**TOWN OF LEESBURG**  
**NOTICE OF PUBLIC HEARINGS**  
**TO CONSIDER REZONING APPLICATION TLZM-2014-0001**  
**POTOMAC STATION MARKETPLACE**

**Staff Contact:** Michael Watkins, Senior Planner, DPZ

**Council Action Requested:** Action on the rezoning application and associated modification requests.

**TOWN OF LEESBURG  
PLANNING COMMISSION PUBLIC HEARING**

Figure 2. Proposed Concept Plan

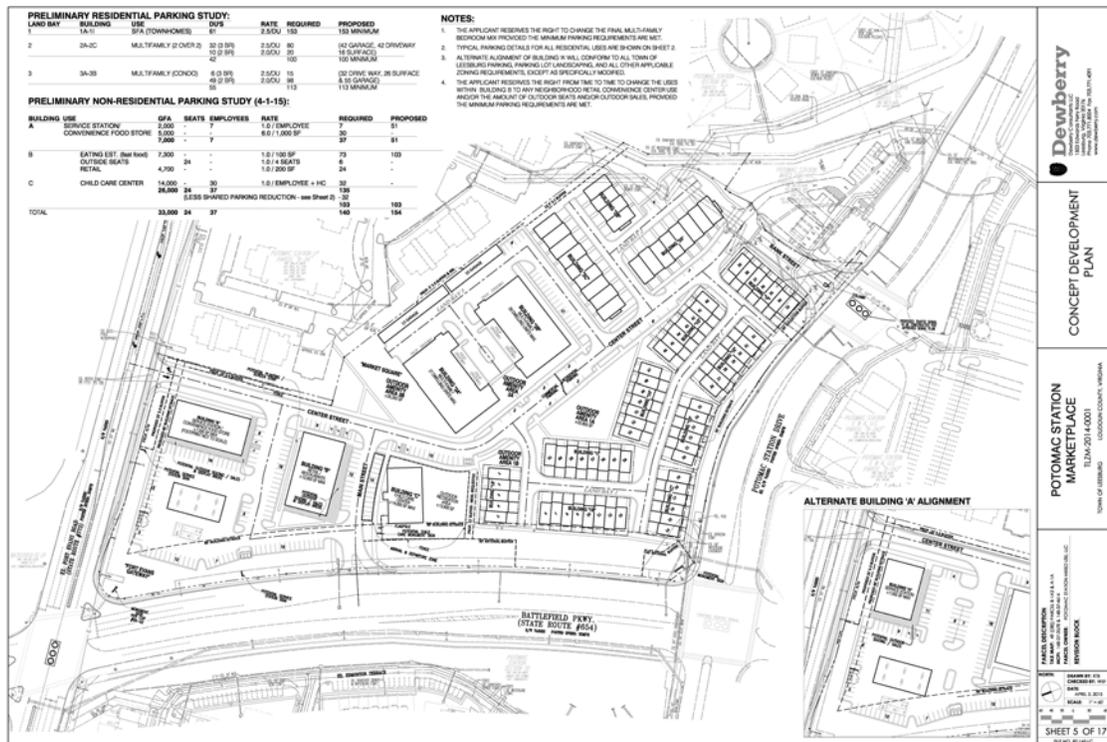
The concept plan generally consists of three pads sites which is inconsistent with a “Main Street” character.

The concept plan generally consists of three pads sites which are surrounded on at least three sides with parking. The only element with the proposed layout that is similar to this concept is Retail Building C. This building includes multiple pedestrian entrances, and a wide sidewalk placed adjacent to the street.
